Internal Photos

Filter NFC Board Changes:

Filter NFC Board w/Antenna

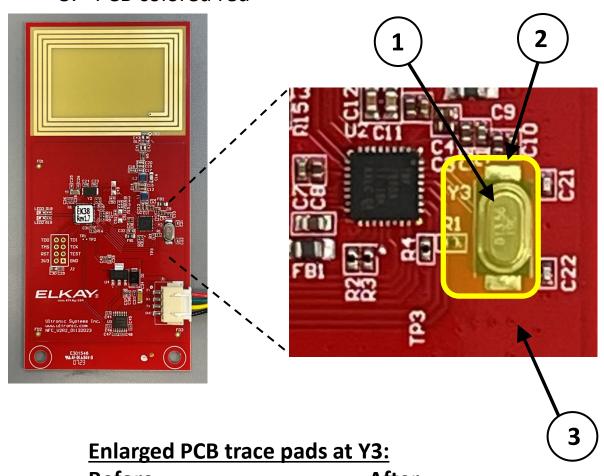
- 1. Alternate microprocessor crystal at Y3
- 2. Enlarged PCB trace pads at Y3
- 3. PCB colored red
